ITS CORPORATION						REV	ECN	DATE	APV
REV	ECN	DATE	TITLE						
		SCHEMATIC, VCXO BD. DUAL OVEN (1145-1204)							
REV	ECN	DATE	MATERIAL		DWG. NO.				REV
			---		1145-3204				7
			FINISH		CHK	JM	7/30/90		
			REL	JCM	8/1/90	B	SCALE ---		SHEET 1 OF 1

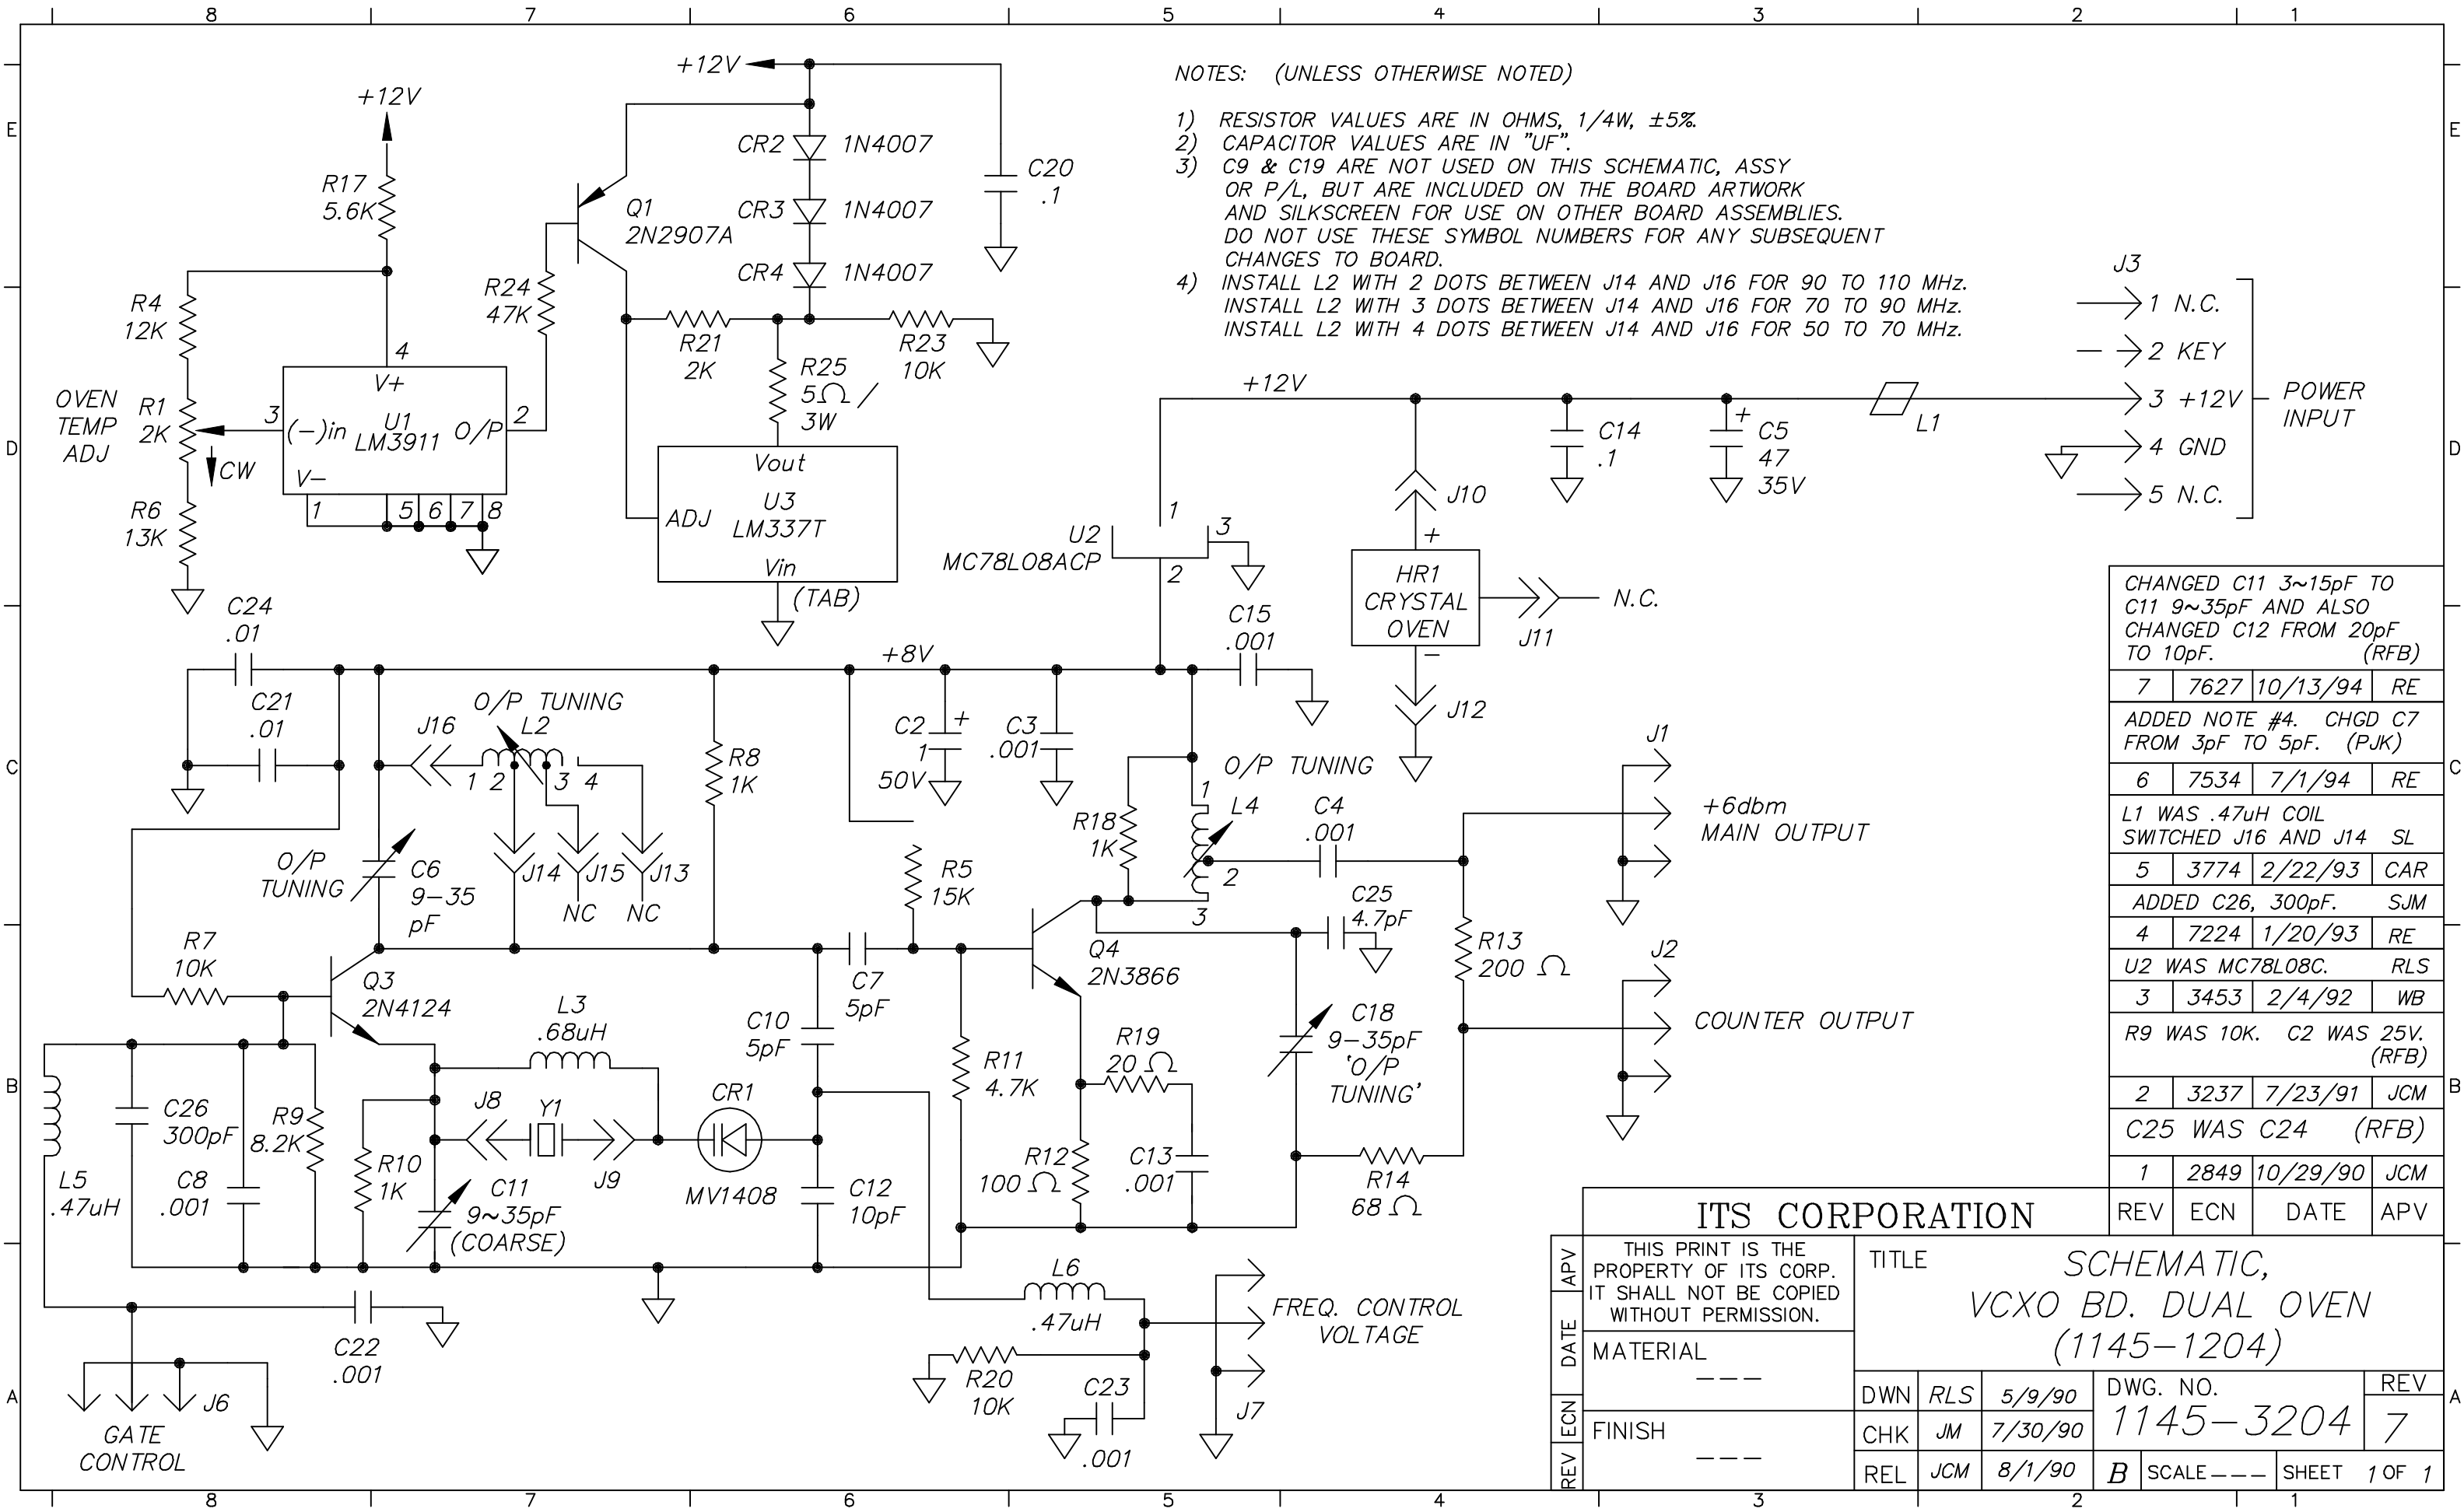
CHANGED C11 3~15pF TO C11 9~35pF AND ALSO CHANGED C12 FROM 20pF TO 10pF. (RFB)

ADDED NOTE #4. CHGD C7 FROM 3pF TO 5pF. (PJK)

L1 WAS .47uH COIL SWITCHED J16 AND J14 SL

ADDED C26, 300pF. SJM

U2 WAS MC78L08C. RLS

R9 WAS 10K. C2 WAS 25V. (RFB)

C25 WAS C24 (RFB)
